# Data Request Issues Resolution: Soil and Water Resources

Public Workshop  
Mission Rock Energy Center  
(15-AFC-02)

August 26, 2016

## 2010 Effective FIRM

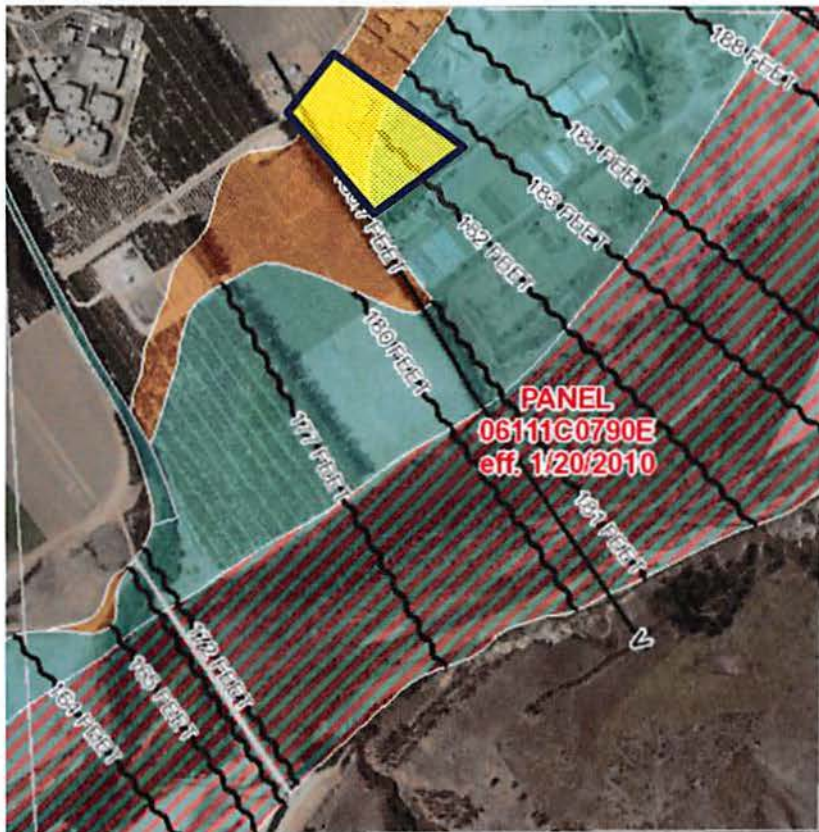
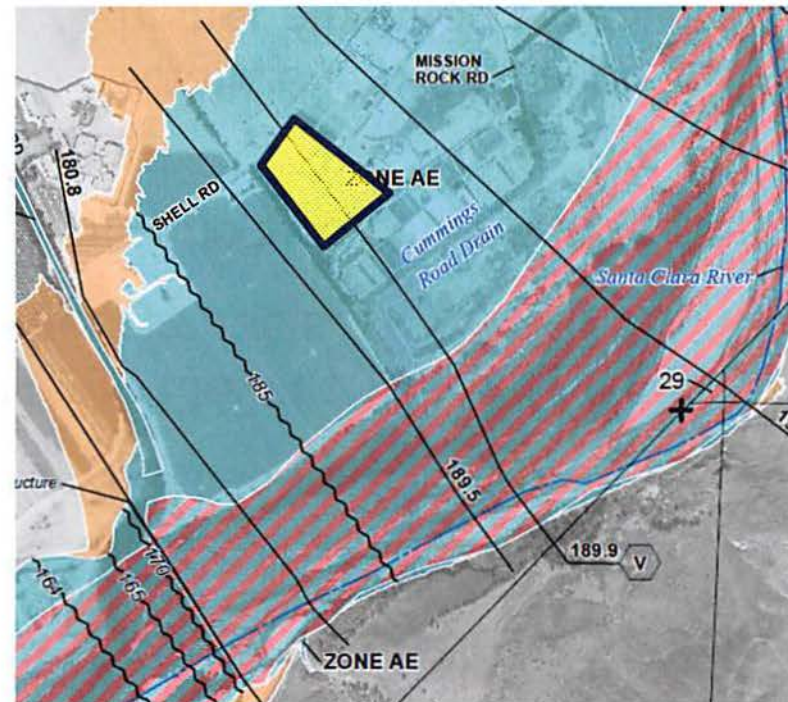
## #68 Timing

### Request:

- FEMA map update
- Floodplain development permit

Need: Inform Committee of possible delays in start of operations.

Intent: Explain the permit process and expected length of time, FEMA's role, and where commissioning and start of operations fit in.

## #69 Base Flood Elevation

AFC: Floodplain 191.3 feet

All foundations 192.3 feet

Need: Elevation change could affect impacts

Intent: Discuss contingency plan

1. Analyze impacts using higher elevation now
2. File petition to amend later

## #73 Slope Protection

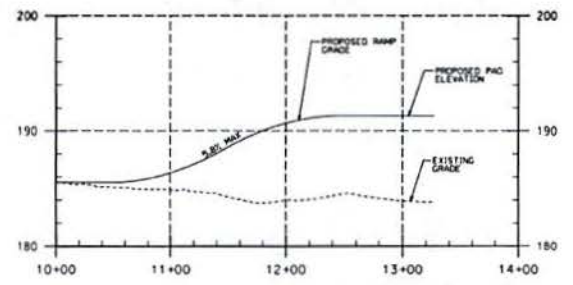
Request:

- Construction profiles (typical)
- Protection from erosion/scour

Need: Fill within floodplain is exposed to flood flows.

Intent: Describe measures of protection and discuss the potential impacts to implement them

Also for: Linear facilities

# Typical Cross Section

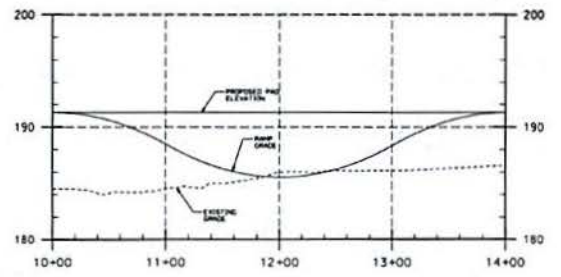
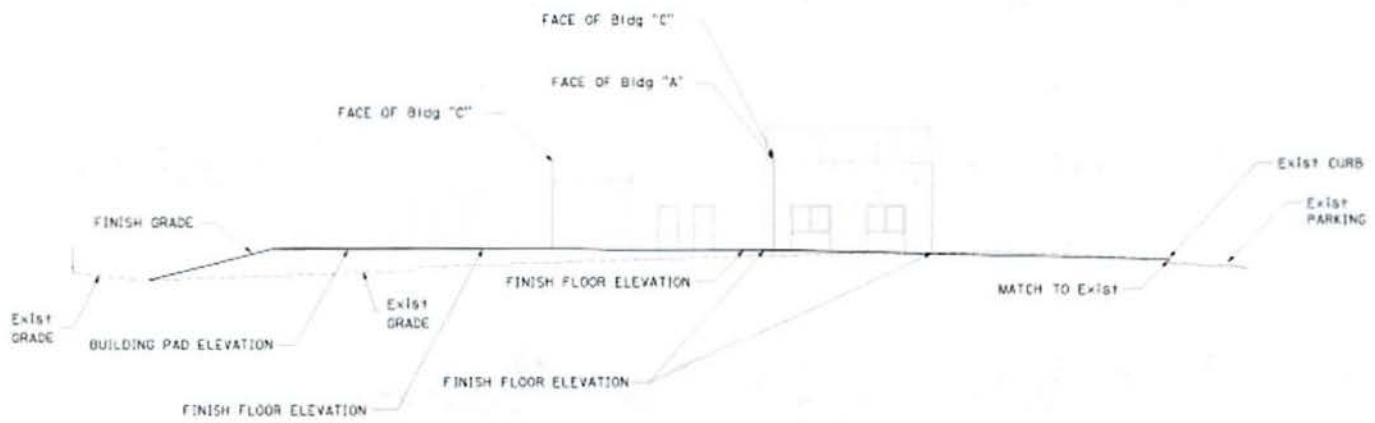
## #71 Profiles

- Earthwork profiles (typical)
- Cross-sections (100-ft intervals)

Need: Preliminary information, similar to Ramp Profiles.

Intent: Show the extent of earthwork required to raise the site. AFC only states “maximum of 10 feet.”

# Hydrology

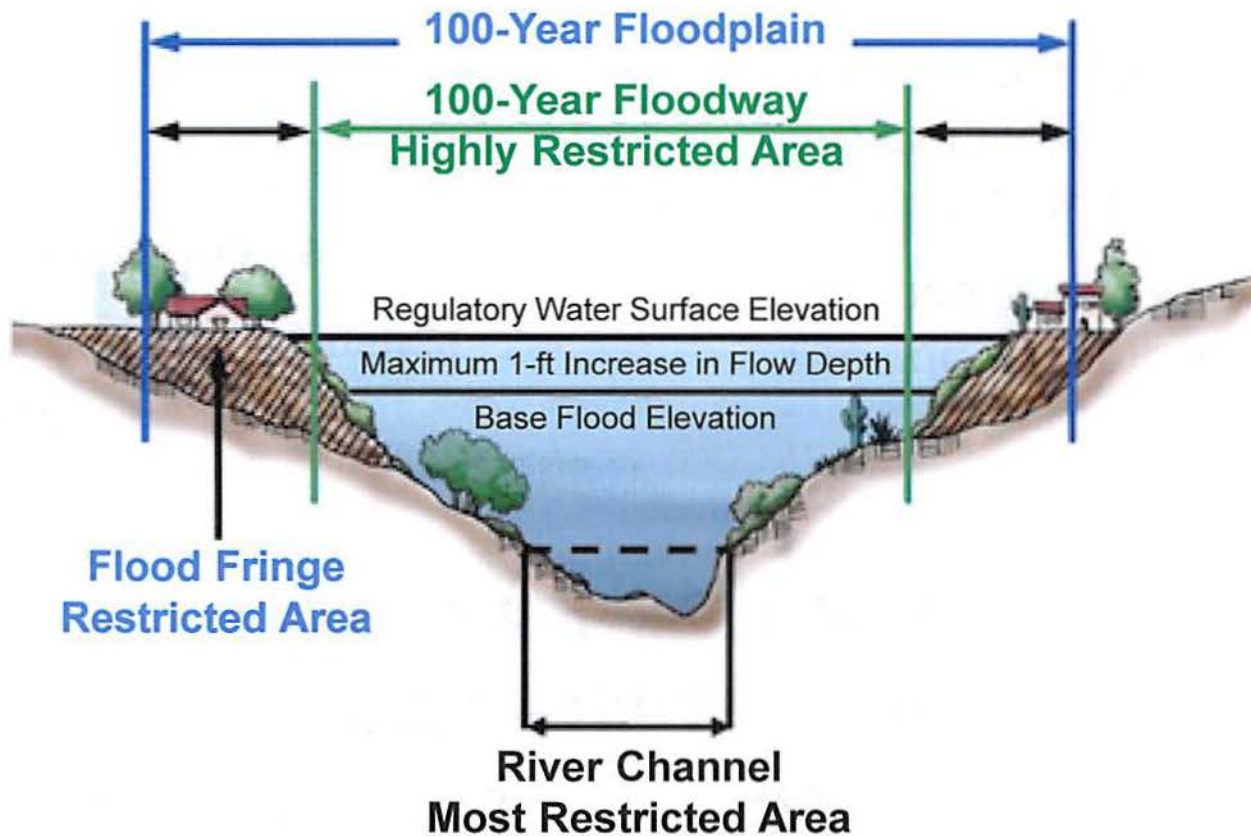
## #74 Offsite Impacts #75 Cumulative Impacts

- Flood characteristics
- Offsite impacts

CEQA analysis

- Provide assumptions used for flood analysis
- Determine whether there are significant impacts to surrounding properties
